Michael Collins,
Manager,
Revised Draft Hanford Solid Waste EIS

**Comments of Heart of America Northwest,
Heart of America Northwest Research Center
on
Revised Draft
Hanford Solid (Radioactive and Hazardous)
Waste Program
Environmental Impact Statement
(RD-HSWEIS)**

Submitted June 10, 2003
To the U.S. Department of Energy (USDOE)

Figure D-12. Roadway Network Included In the Statewide Model, with Currently Restricted and Cracked Bridges.

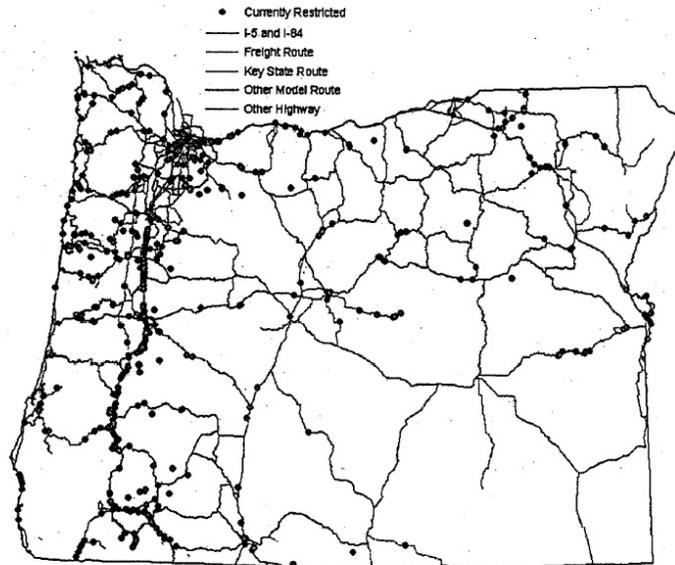
The Revised Draft HSWEIS does not include any new analysis of the risks or impacts of transporting wastes through Oregon and Washington, or along their specific cross-country routes. Instead, the revised draft HSWEIS only *extrapolates* figures based on the road miles in each state on the interstate highway routes that utilize Interstate 84 and 82 to the Washington border, and from there to Hanford. The WMPEIS included numerous statements that before any waste management decision to ship waste and before actual transportation would commence, USDOE would conduct site, route and waste specific analyses in an appropriate NEPA review. Simply showing the results of the existing hypothetical model for the hypothetical number of highway miles in Oregon and Washington for a preferred (but not legally binding) route, fails to meet this commitment and requirement. The model used was a 1982 analysis and 1990 data, which is woefully out of date.

Use of Interstate 84 requires passing over two of the ten most dangerous interstate highway mountain passes in the nation (E.g. Deadman's and Emigrant Hill). The Interstate 5 route not only exposes public along highly crowded urban highways, but the Siskiyou Mountains and the Columbia Gorge. USDOE has failed to consider the actual condition of highway bridges in Oregon. Oregon has unique design and structural flaws causing failure of many bridges.
